ATtiny1614/1616/1617 Automotive

Automotive Silicon Errata and Data Sheet Clarifications

The ATtiny1614/1616/1617 Automotive devices you have received conform functionally to the current device data sheet (www.microchip.com/DS40002021), except for the anomalies described in this document. The errata described in this document will likely be addressed in future revisions of the ATtiny1614/1616/1617 Automotive devices.

Figure 3-1. Block Diagram

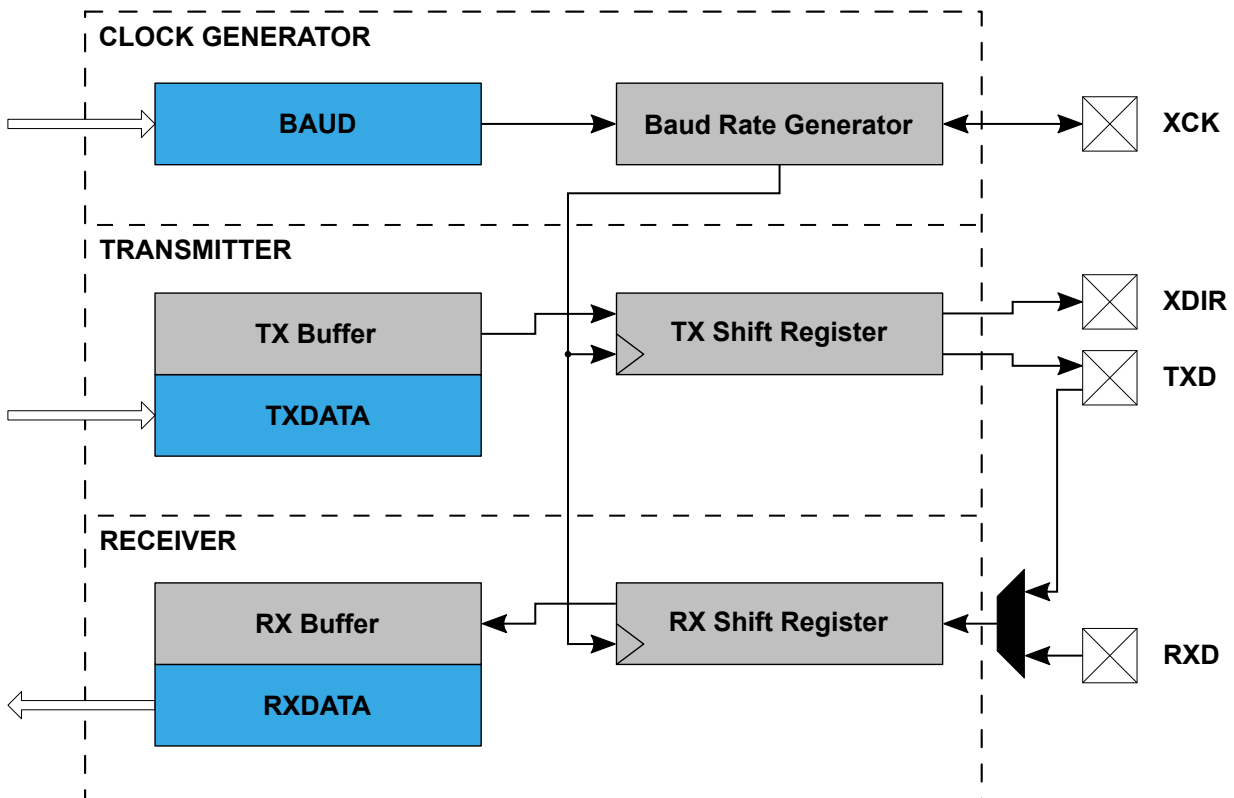
The block diagram is missing that USART TX is double-buffered from Figure 25-1 in the data sheet. Added **TX Buffer** is shown below.

The transmitter consists of a **two-level** write buffer.

The data transmission is initiated by loading the **Transmit Data (USARTn.TXDATAL and USARTn.TXDATALH)** registers with the data to be sent. The data in the **Transmit Data registers are moved to the TX Buffer** once it is empty and then to the Shift register once it is empty and ready to send a new frame.

Figure 39-67. OSC20M Internal Oscillator: Frequency vs. Temperature

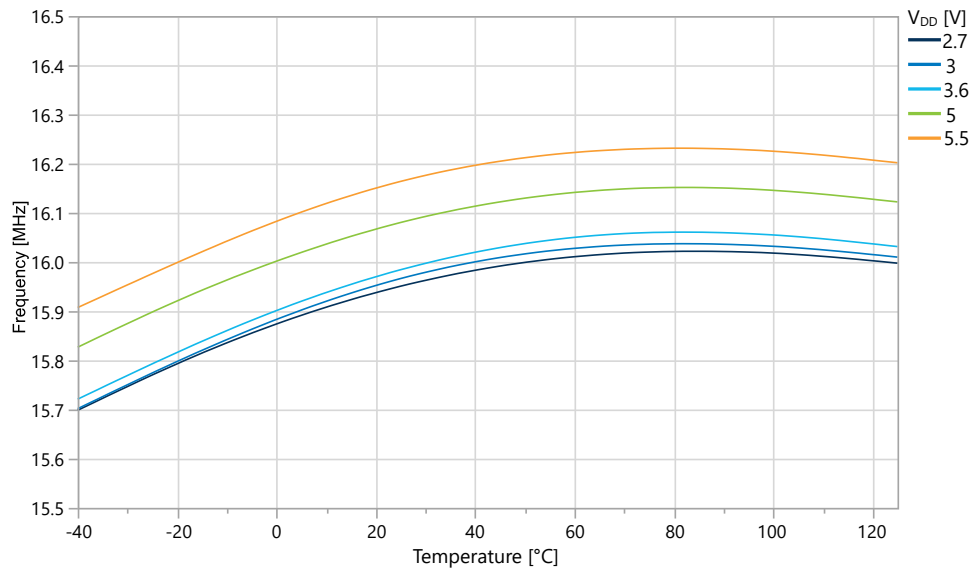
A clarification has been made to *Figure 39-67. OSC20M Internal Oscillator: Frequency vs. Temperature* and *Figure 39-68. OSC20M Internal Oscillator: Frequency vs. V_{DD}*, due to incorrect frequency ranges presented in the plots. Correct plots are shown below.
